NIBLEY CITY COUNCIL MEETING AGENDA Thursday, February 16, 2017 – 6:30 p.m. Nibley City Hall 455 West 3200 South, Nibley, Utah

Nibley City Council Agenda Report for February 16, 2017

Description	Discussion and consideration of a building design and site plan review for Heritage Vet Clinic/Kennel located at 2365 S Heritage Drive
Department	Planning
Presenter	Stephen Nelson, City Planner
Applicant	Jim Miller
Background	By way of general comment, in the past, when a site plan has been for a single, small building, the opinion and direction of the Council and Planning Commission has been that a concept presentation could be waived and that preliminary and final site plan could be done as one approval. The approval being requested at this time is the final site plan and building design.
	Heritage Vet Clinic/Kennel is a small-animal vet clinic being proposed to be constructed at 2365 S Heritage Drive. This property is zoned Commercial. A small-animal vet clinic is listed as a conditional use in the commercial zone. That conditional use permit is not on the agenda at this time and would be considered by the planning commission at the time of businesses licensing.

SIERRA COMMERCIAL PARK, LOT 7 GRADING PLAN

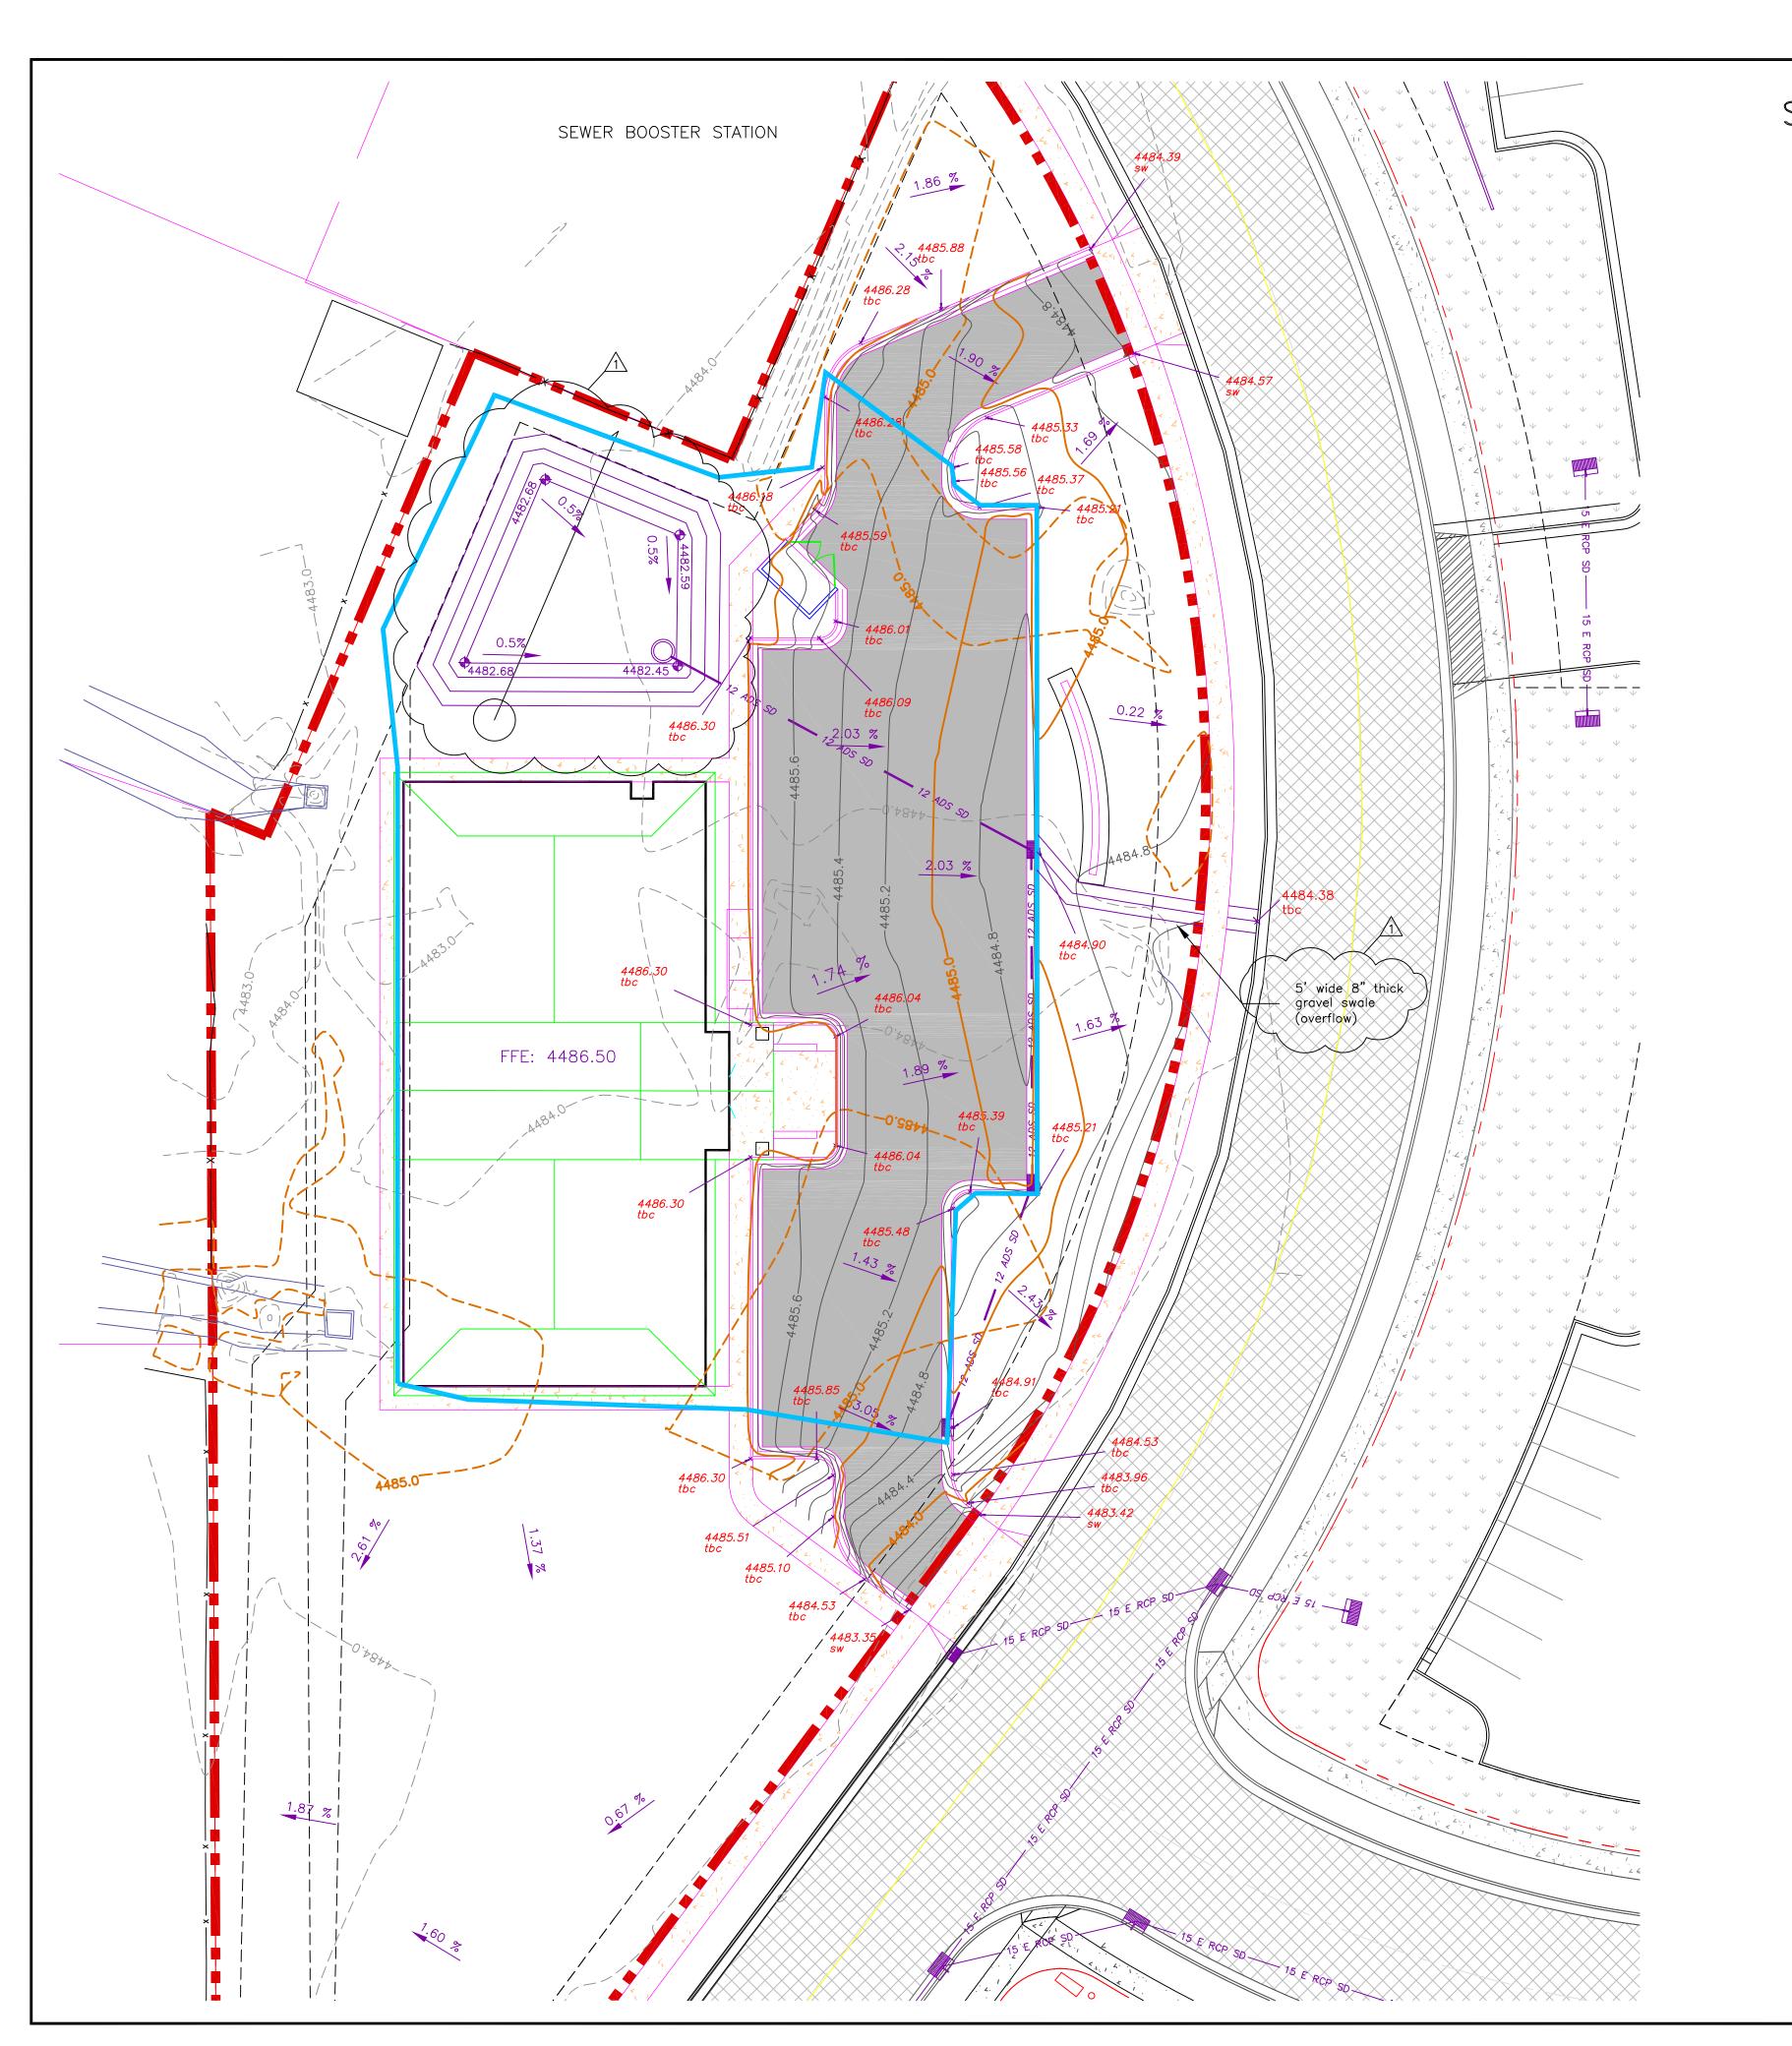
Plat: The building is being proposed on a 1.5 acre lot in the Sierra Commercial Subdivision. The location of the building complies with the 20 ft. front setback. The Utility easements are properly notated and labeled. The plat also meets the requirements to show the surrounding buildings and streets within 300 ft. The applicant has included the construction drawings for the improvements to the utilities and infrastructure. Plans for these improvements comply with Nibley City Design Standards.
	The site plan also includes stormwater infrastructure that meets Nibley City Standards.
	Easement:
	There is a sewer easement located along the west side of the property, behind the building. This is the main sewer line that runs to the Hansen lift station, (the City's primary lift station) is located on this applicant's property, between the proposed building and the west property line. The plat currently shows the building sitting just outside of the easement. Their engineer has relocated

the building just outside the easement. However, a section of the building footing is in the easement. Because the footing is in the easement, the developer has agreed to have the back foundation wall 8' ft. deep and to sign a liability waiver to indemnify the city against any potential damage his building might sustain if the City ever needed to conduct repairs to the sewer line.
